Development Application No.:	25004790
Applicant:	Department for Infrastructure & Transport
Proposal:	Crown DA for a change in the use of the land to a spoil reuse facility, filling of land and construction of temporary buildings, facilities and infrastructure
Subject Land:	Adjacent Port Expressway, Dry Creek (Allotments 501 & 502)

EPA Development Application Referral Response

Development Application Number	25004790
Applicant	Department for Infrastructure and Transport C/- Mike Davis, Mott MacDonald
Location	Lot 506 North Arm Road, Dry Creek SA 5094 (CT 6239/959)
Proposal	Change in use of the land to a spoil reuse facility, filling of land and construction of temporary buildings, facilities and infrastructure

Development Application No	25004790
Applicant	Department for Infrastructure and Transport
Description	Spoil reuse facility-Part 2
Location	North Arm Rd, Dry Creek (Lot 502), Gillman
Zone/Sub Zone/Overlay	Strategic Employment/Gillman/Coastal Areas Overlay
Council	Port Adelaide Enfield
Planning Authority	State Commission Assessment Panel

Figure 1- Subject development site and proposed development

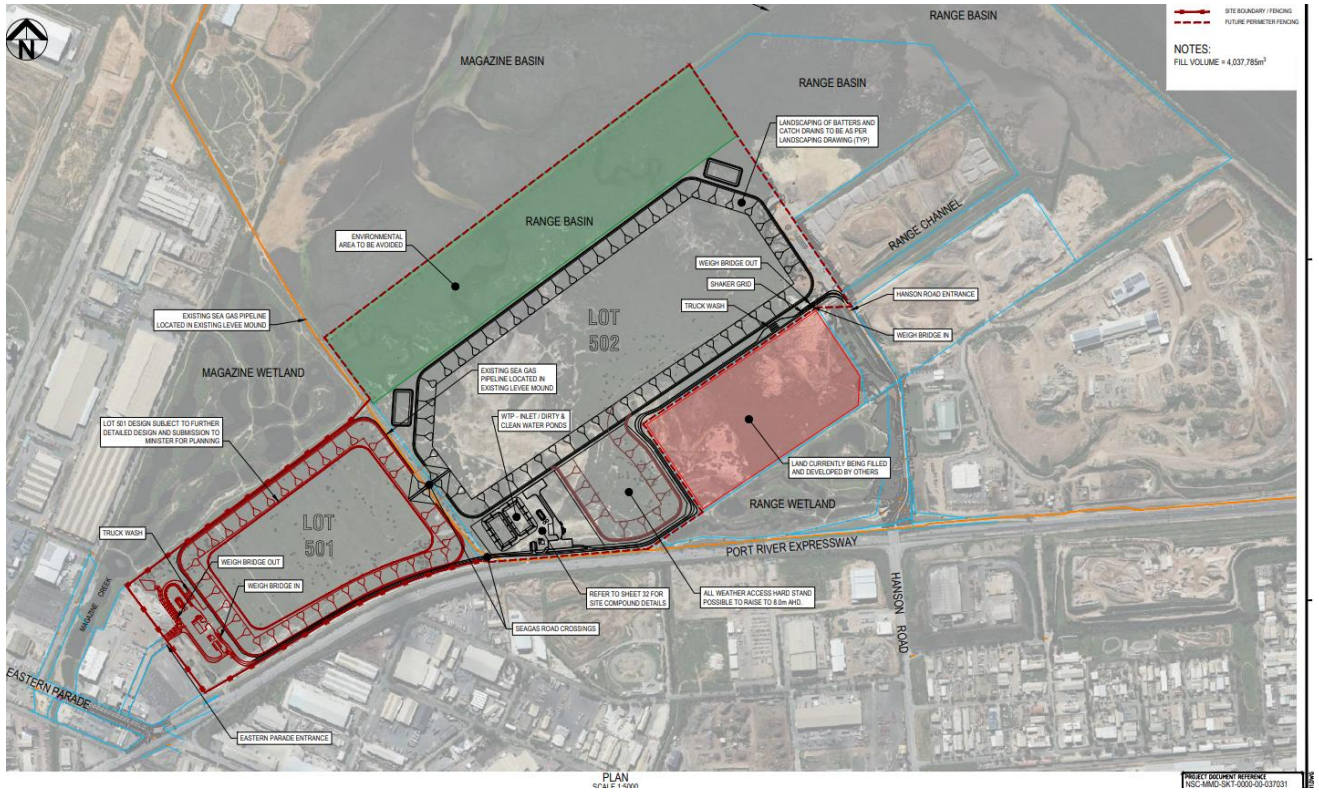
The Board notes that the plans submitted (Figure1) indicate that Option 2 is the proposed fill extent being pursued as part of this application. It also notes that Option 3 would have the least impact on the TEC (noting that it excludes an area to the south which is suitable for fill) whilst Option 1 has the next least impact. The Board's preference is for a fill platform that offers the least impact on coastal habitats and species. The Option 1 outline could potentially provide this, but consideration should be given to a non-linear edge on the western side of the fill mound to accommodate the full extent of the stranded tidal creeks and saltmarsh habitat. This would provide the opportunity for the future re-introduction of tidal flows to the remaining, unfilled site for habitat restoration.

Figure 3. The different vegetation associations surveyed across the Study Area, highlighting the Subtropical and Temperate Coastal Saltmarsh TEC.

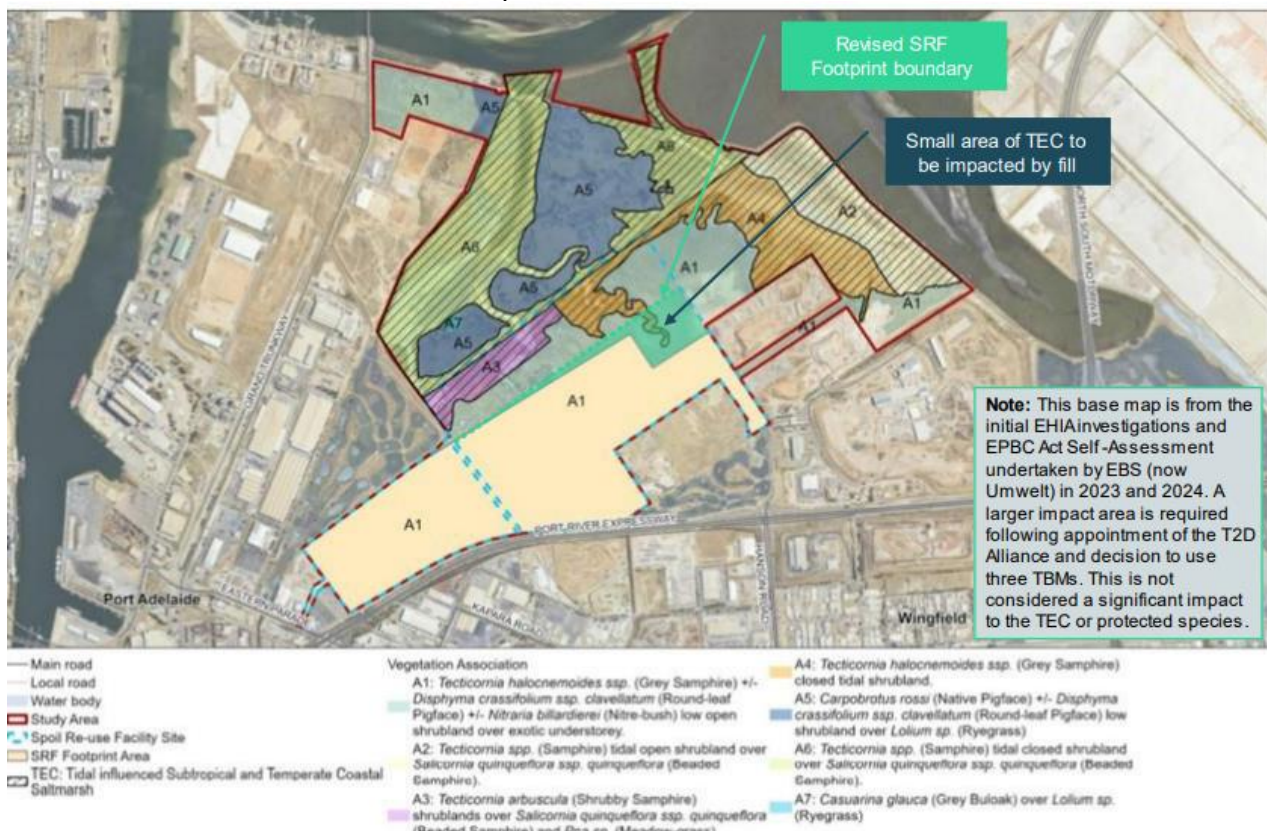
- the Project should avoid cutting off tidal influence to the EPBC Vulnerable Subtropical and Temperate Coastal Saltmarsh TEC. This TEC area provides habitat for EPBC Act listed threatened water birds. (Refer Figure 3);
- impacts to the higher quality terrestrial vegetation associations that are dominated by native species should be avoided. Maintenance of tidal influence to these communities will protect the quality of the vegetation, as predominantly native species can withstand the highly saline and waterlogged conditions.

Figure 5- Fill platform options

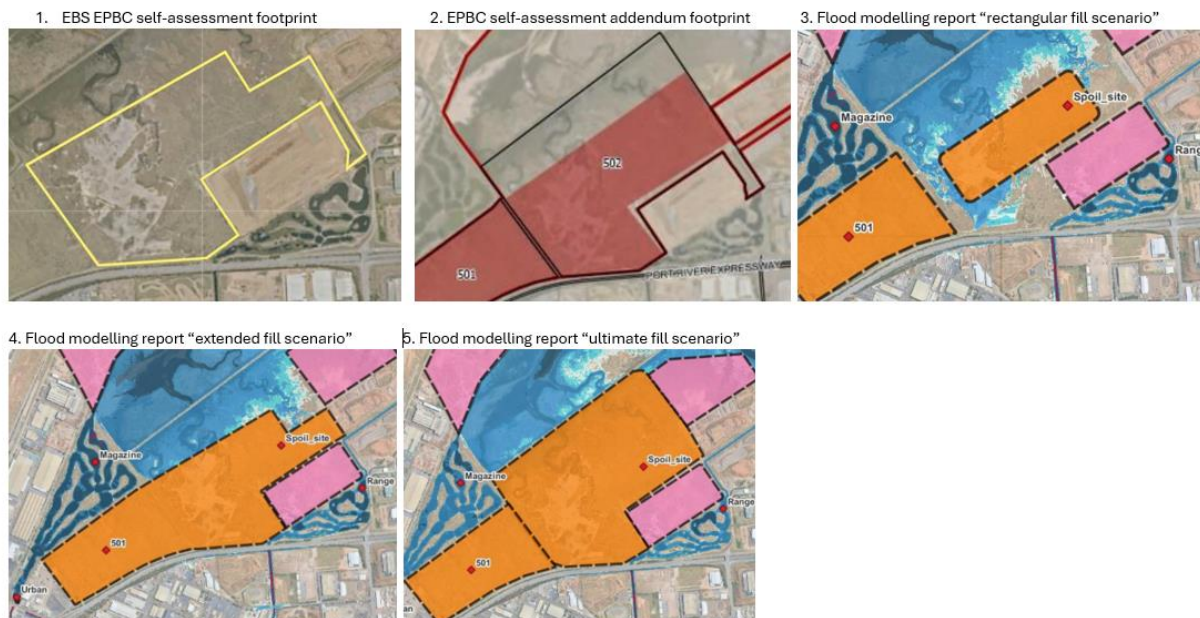
The Board has reviewed the information provided and notes a range of fill options that would have varying impacts on the adjacent Threatened Ecological Communities (TEC). These 5 options (identified by the Board) include:

- Option 4. Extended fill scenario – which Like Option 1 also impacts on unlisted stranded saltmarsh and tidal creeks **Mott MacDonald-Flood Modelling Report**;

- Option 5. Ultimate fill scenario which has significant impacts on *Subtropical and Temperate Coastal Saltmarsh* TEC and impacts on stranded saltmarsh and tidal creeks **Mott MacDonald-Flood Modelling Report**.
